**WVSU RESEARCH AND DEVELOPMENT CORPORATION
KANAWHA COUNTY, WEST VIRGINIA
STINGER PRODUCE MARKET UPGRADES**

**ADDENDUM #2
August 13, 2026**

THRASHER PROJECT #T60-11496

C2.00

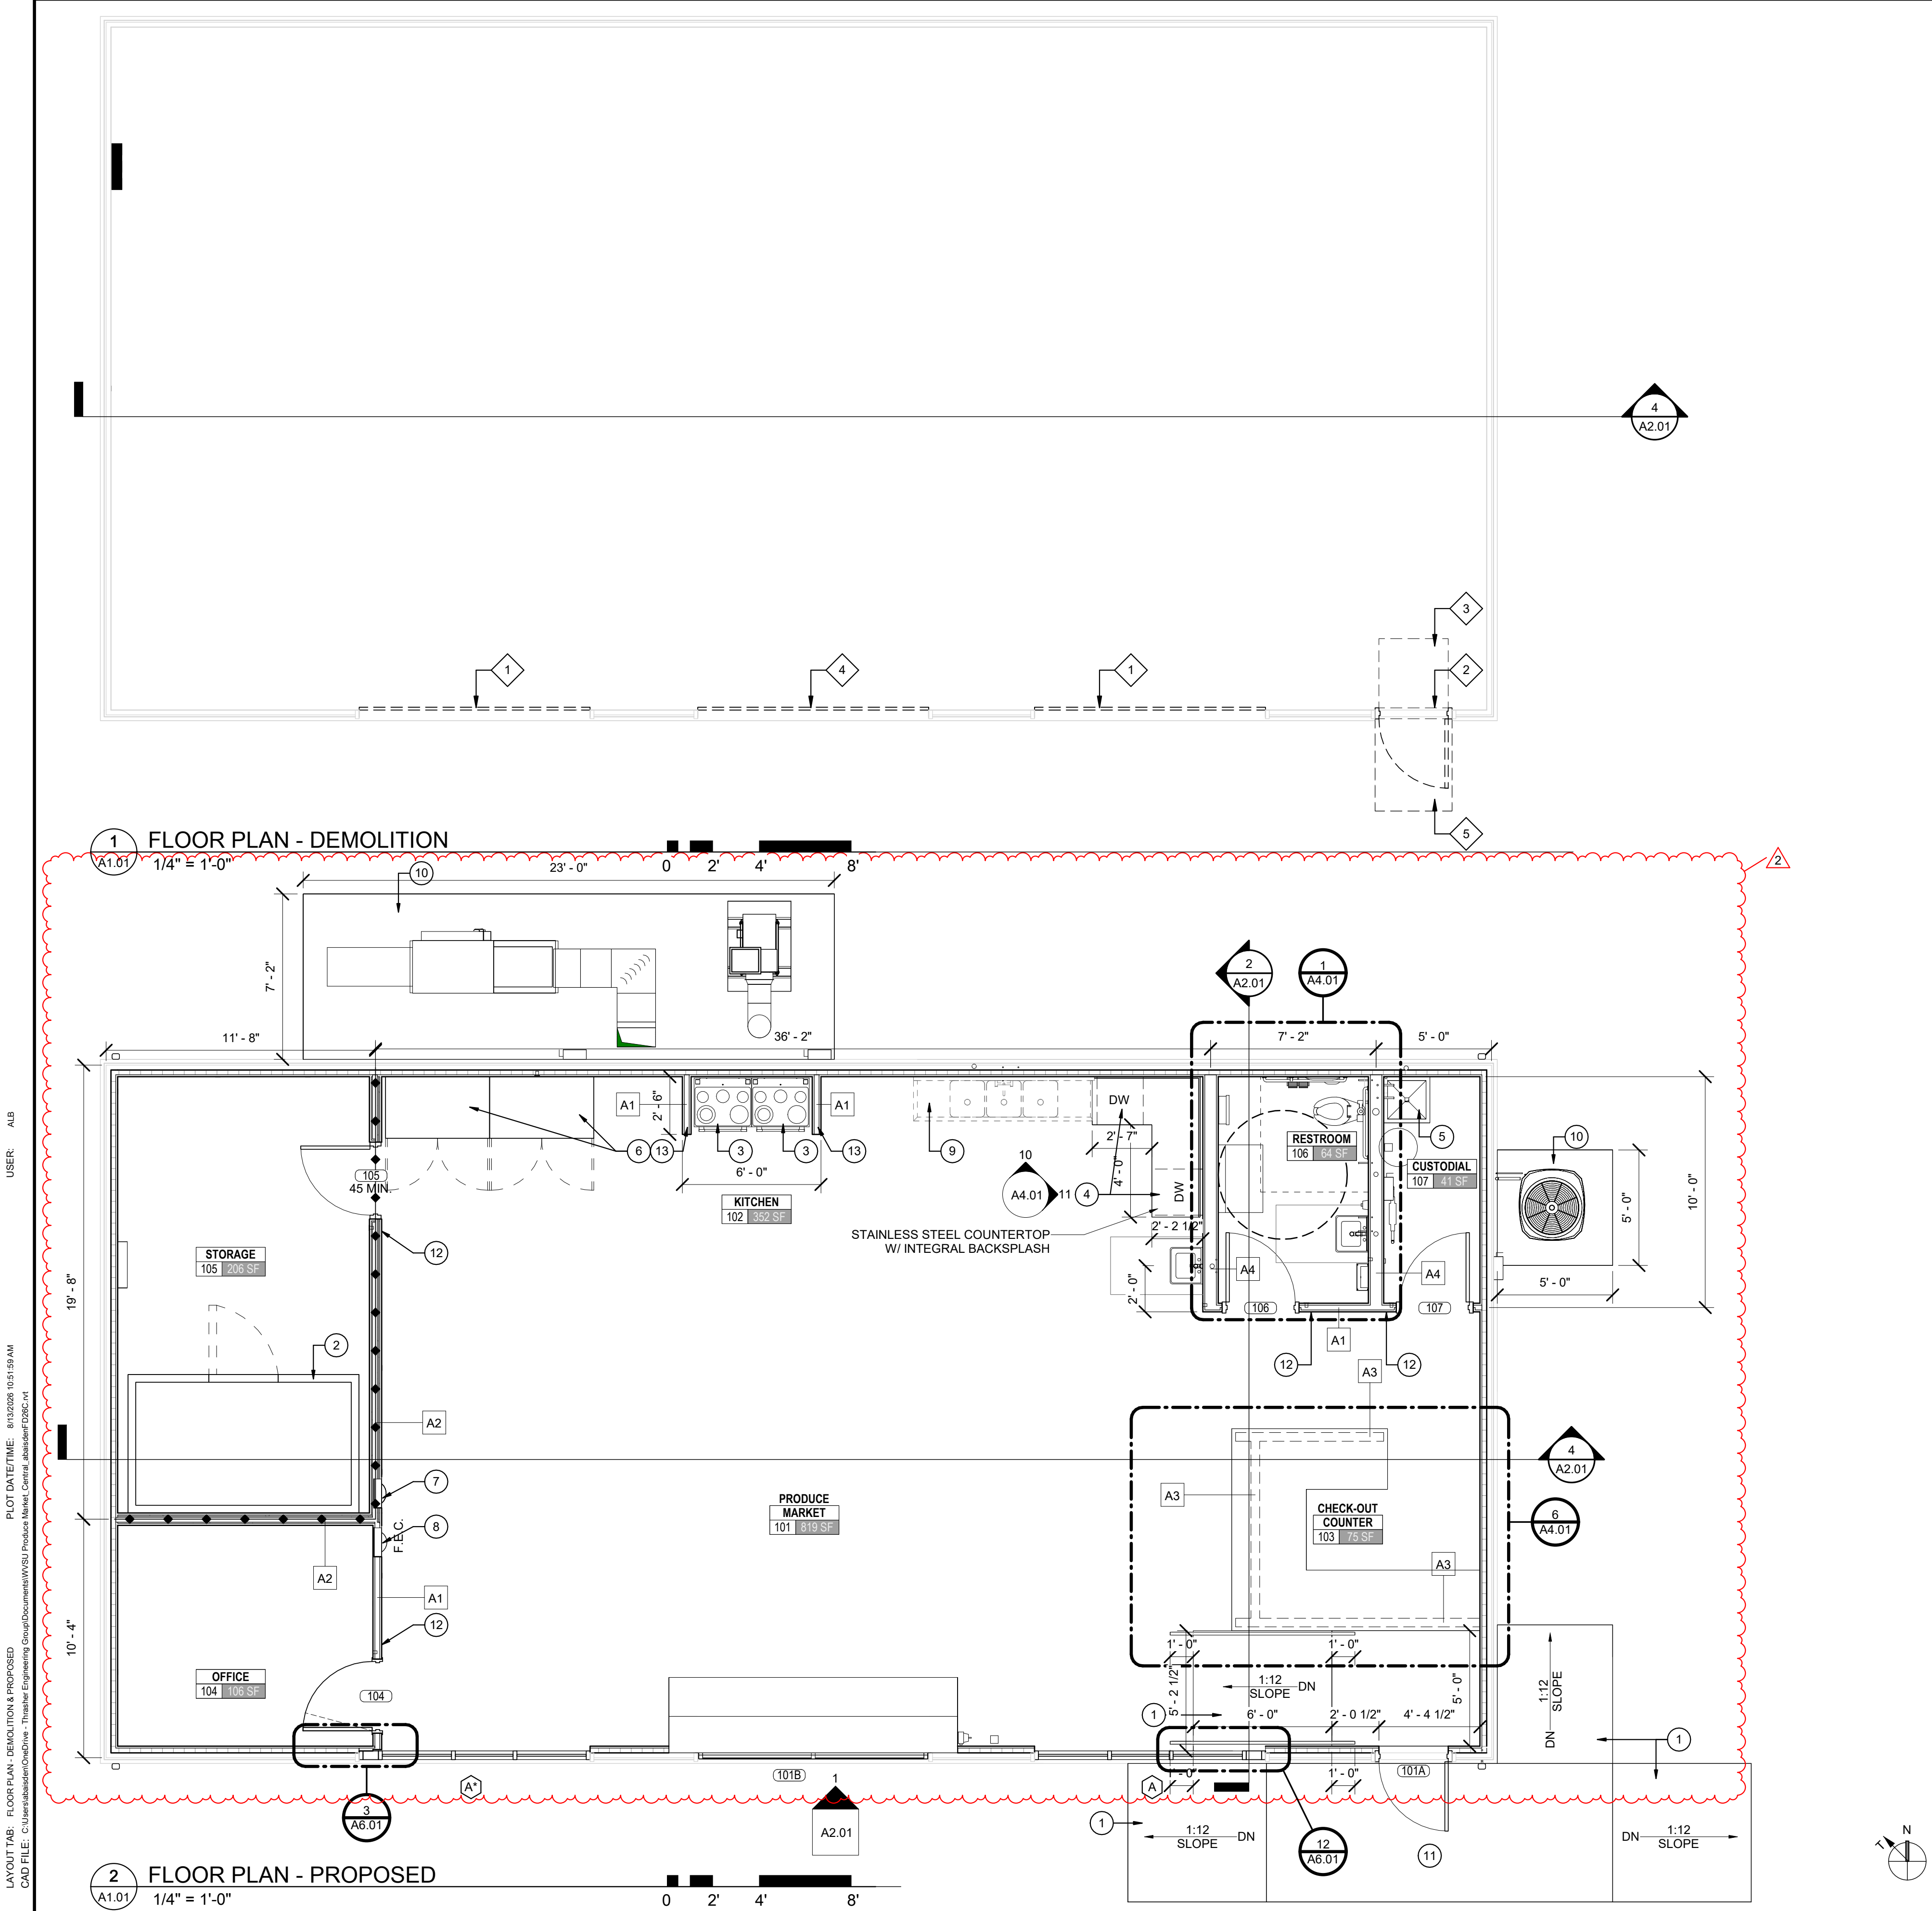
1. C2.00 – Replace sheet – added pipe extension for gutters, labels for new flush concrete, put the conduit for electric service and communication on the same path to an existing utility pole.
2. C3.02 – Revised integral sidewalk detail for flush concrete walkway.
3. These sheets have also been revised within this addendum: A1.01, A2.01, A4.01, A6.01, E4.01 and P2.00.

Architectural and mechanical drawings refer to civil drawings for concrete pads for HVAC. C3.02 provides detail of turndown slab with reinforcement and depths, and references plan for width. C2.00 (plan) drawing does not provide width. Please provide dimensions.

Reference Sheet C2.00 – At the note of “Flush Concrete Sidewalk”, could it be clarified if this is to be new concrete? It states existing within it.

Reference Sheet C2.00 – The storm pipe for the downspouts do not indicate sizing, etc. It also does not show being extended to the other set of downspouts. Please clarify.

Reference Sheet A1.01 – The condensing unit does not appear to be on a concrete pad (no Note #10) but Sheet C2.00 shows that it is. Please clarify.

Dimensions added to sheet A1.01 and sheet C2.00. A detail of the typical pad is on sheet C3.02

Yes, it shall be new concrete and shall be in accordance with detail “integral sidewalk” on sheet C3.02.

The drainage pipe has been extended to pick up all the downspouts and shall be an 8" diameter PVC pipe.

A1.01

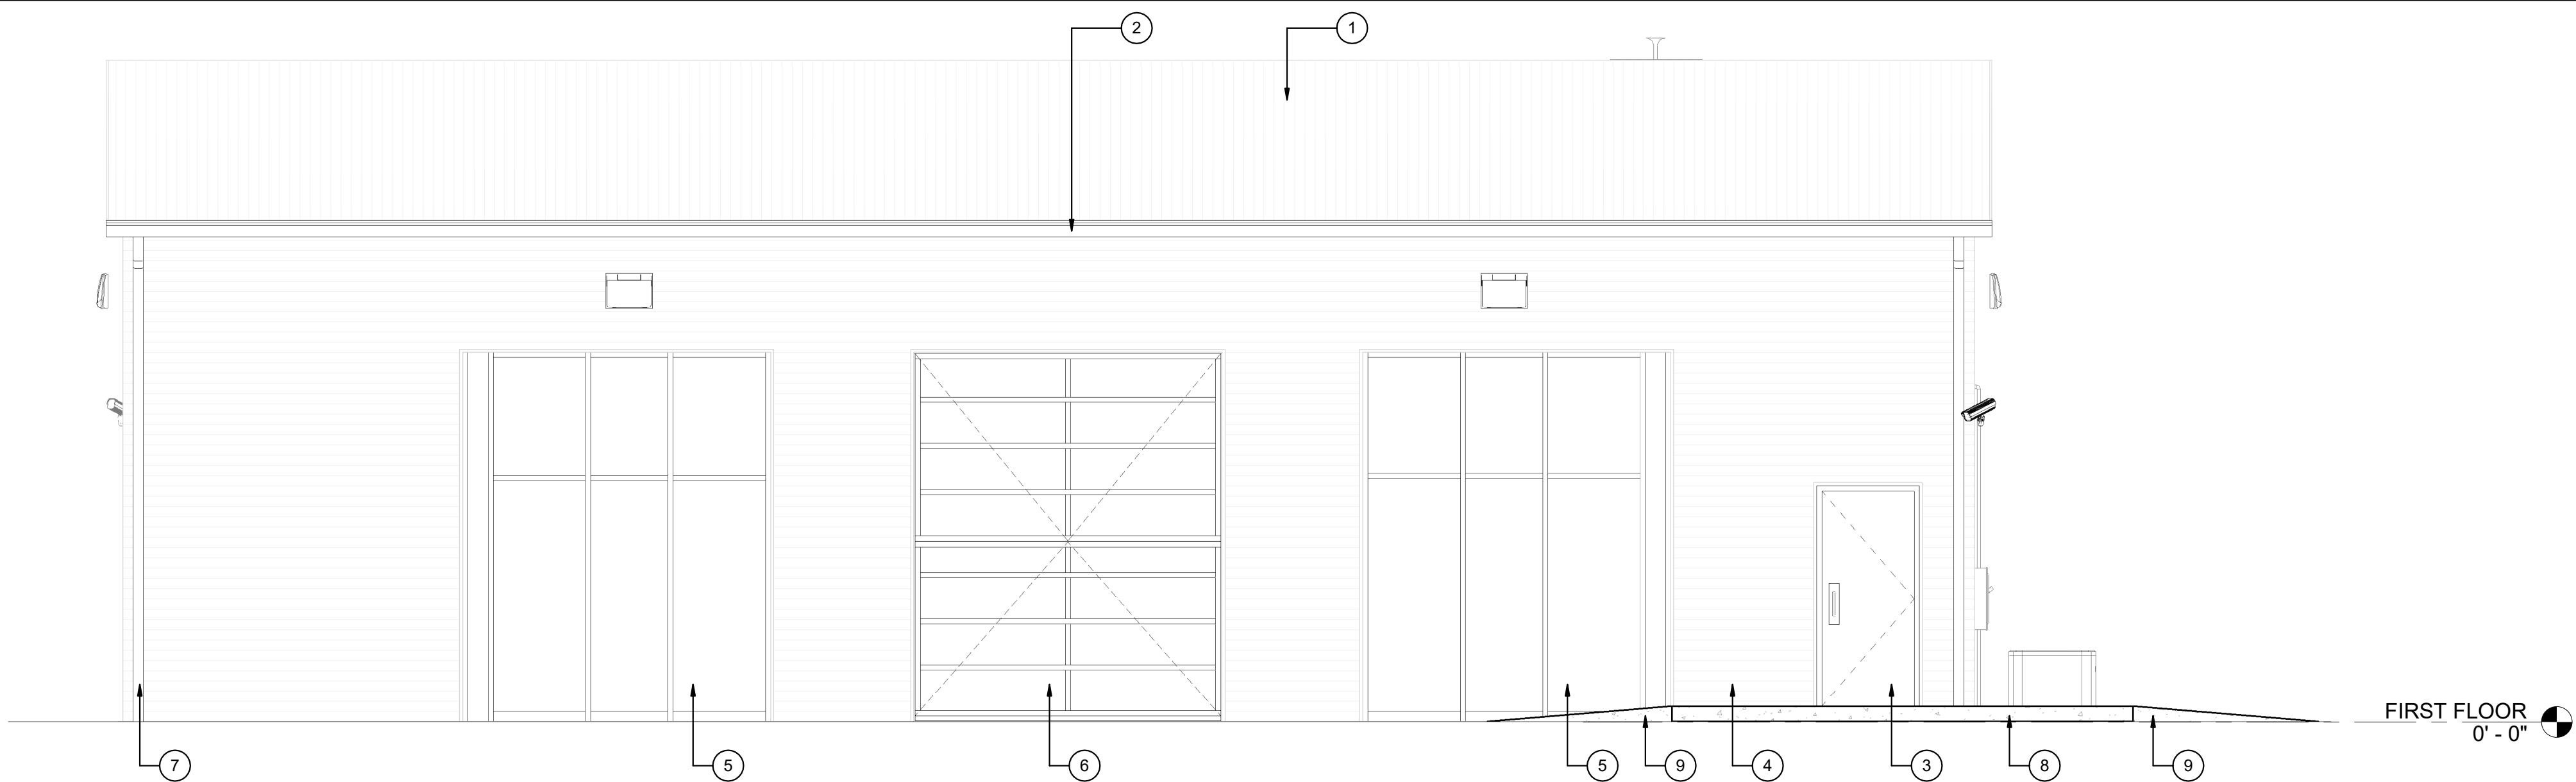
Reference Sheet A1.01 – Please confirm that the ramp railing does not need extended along the Check-Out counter on the ramp landing.

Revised in this addendum.

Added dimensions to this addendum drawings on how far Ramp railing extends.

4 BUILDING SECTION
A2.01 1/4" = 1'-0"

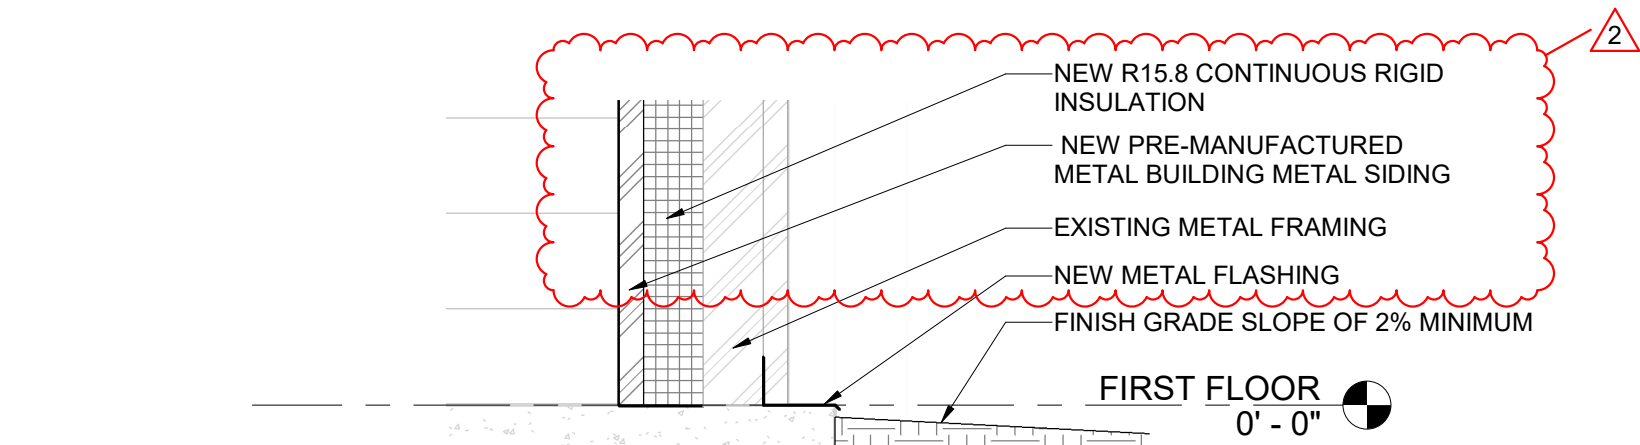
A2.01 – Detail 4 appears to show the restroom wall (A4) extending full height to the underside of the metal roof. On G1.01, A4 wall type is shown as terminating at the 2x4 wood framed ceiling with drywall. Please provide clarification.

A4 terminates at the 2x4 wood framed ceiling with drywall.

5 BOTTOM CONDITION
A2.01 1 1/2" = 1'-0"

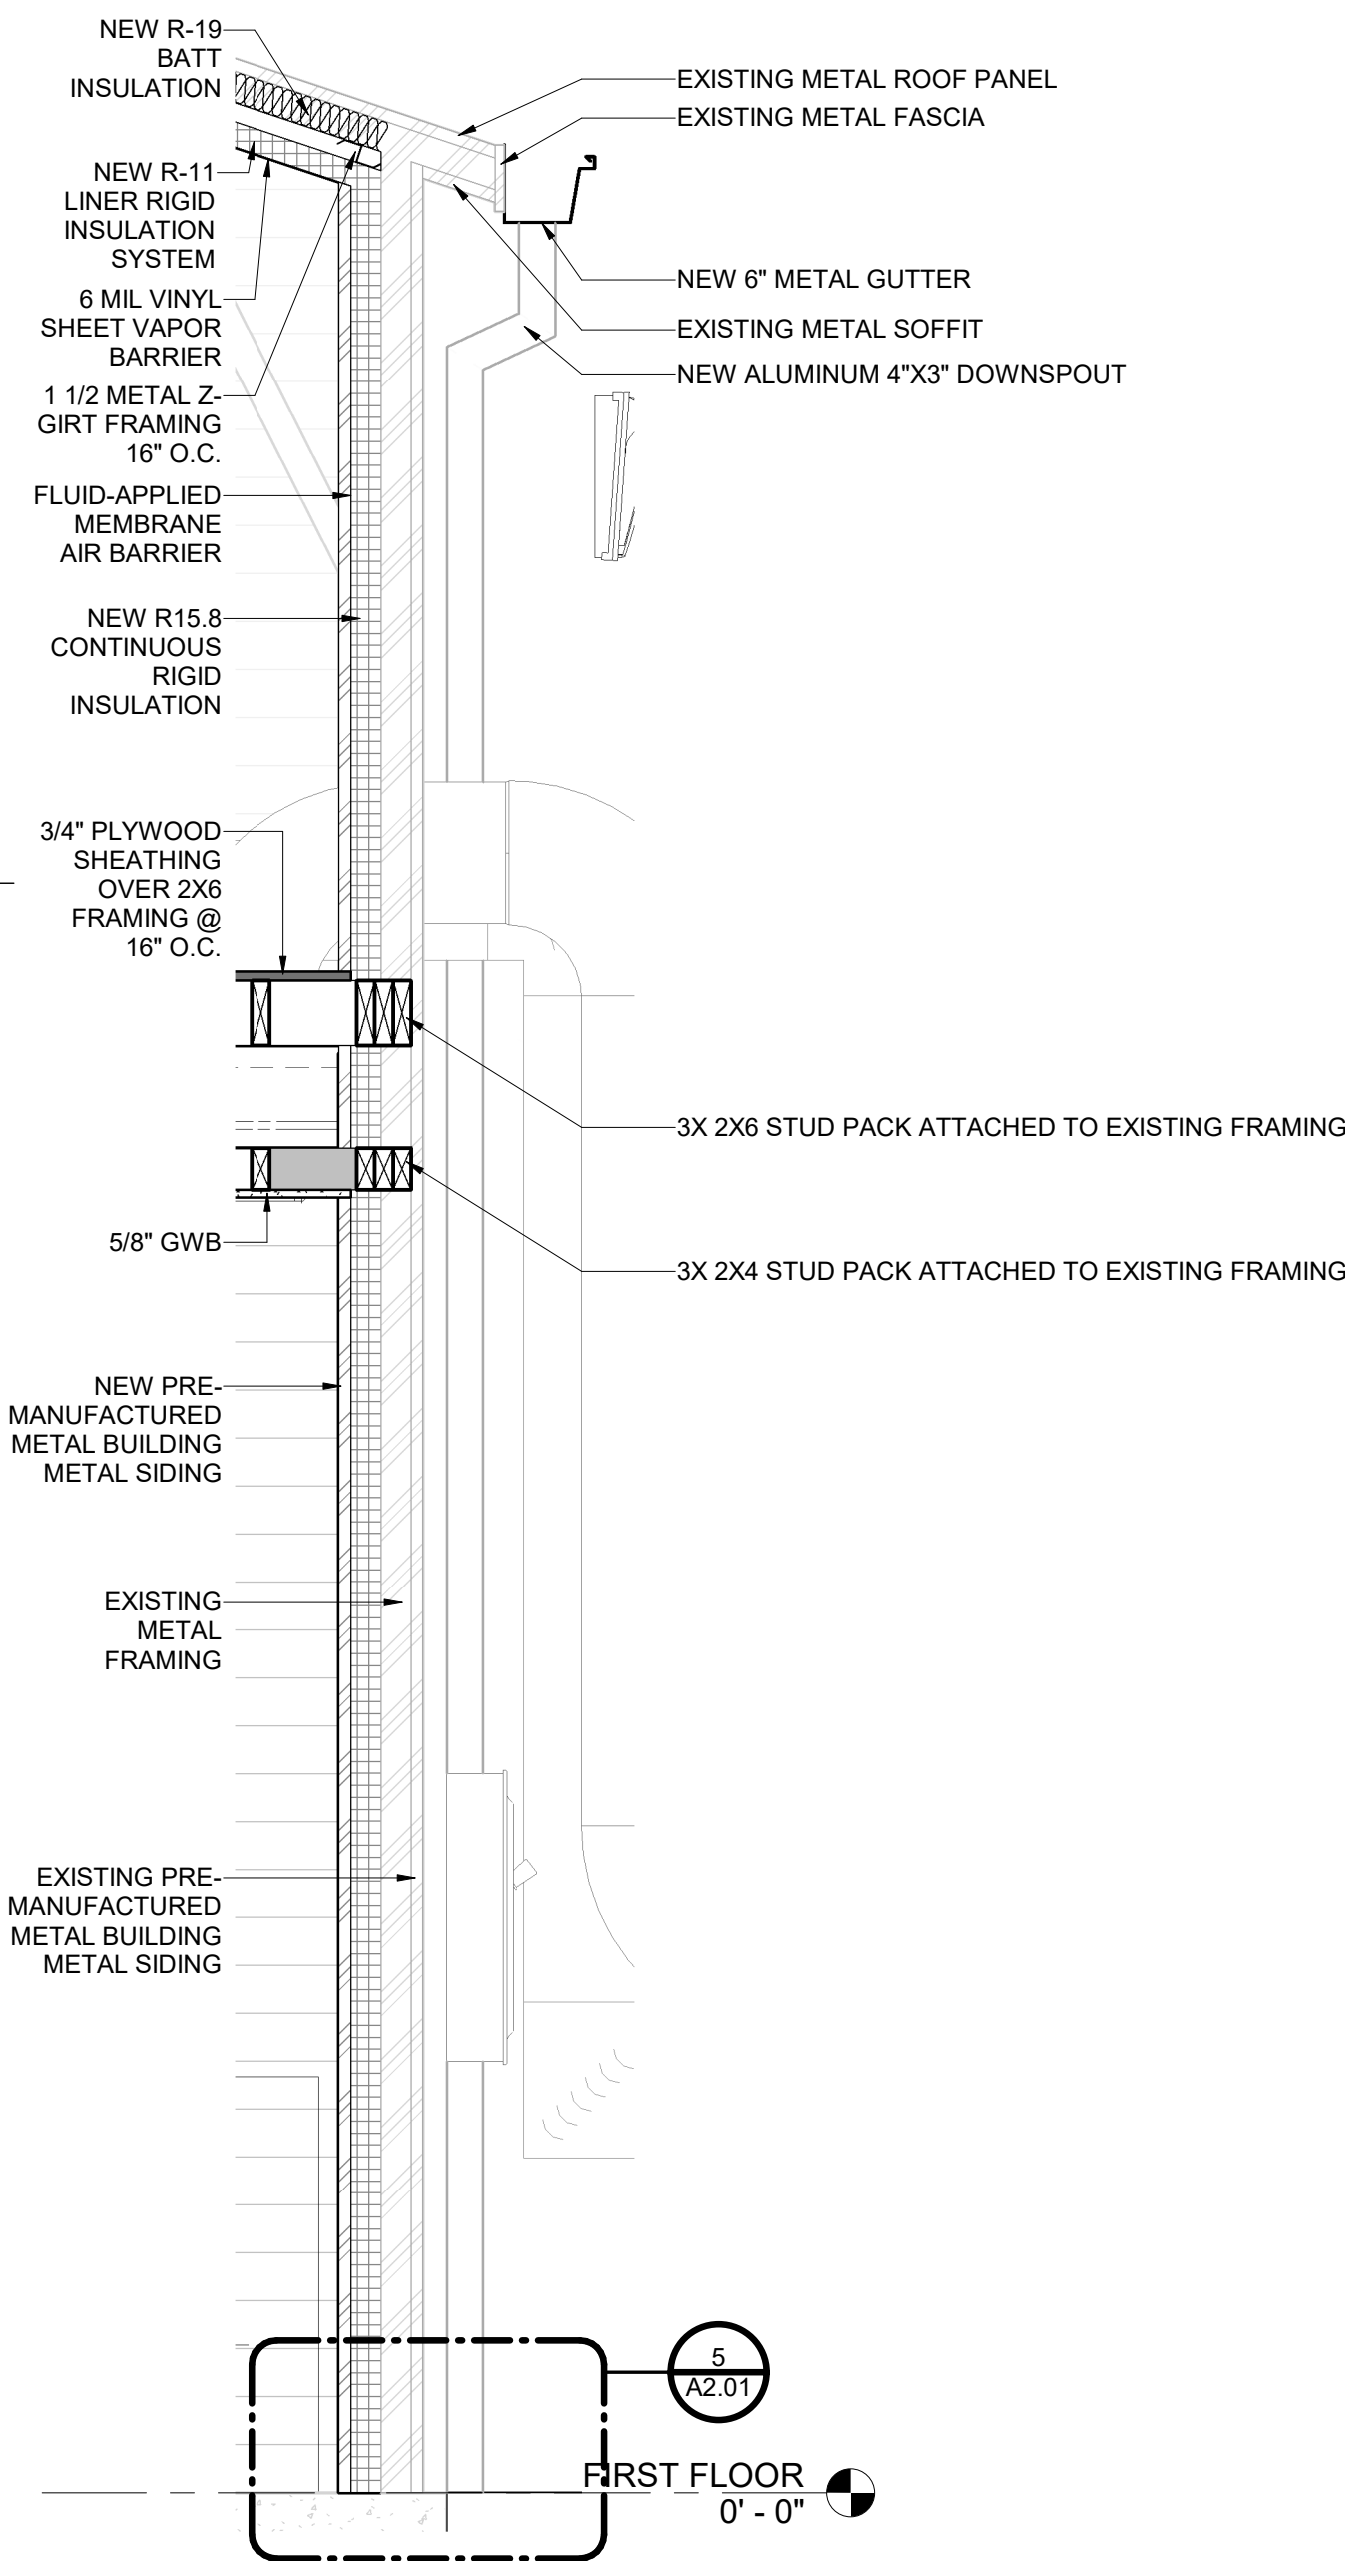
Reference Sheet A2.01/Detail 5 – Is this detail applicable to the project? It indicates new exterior siding but all other drawings indicate existing to remain.

Revised in this addendum.
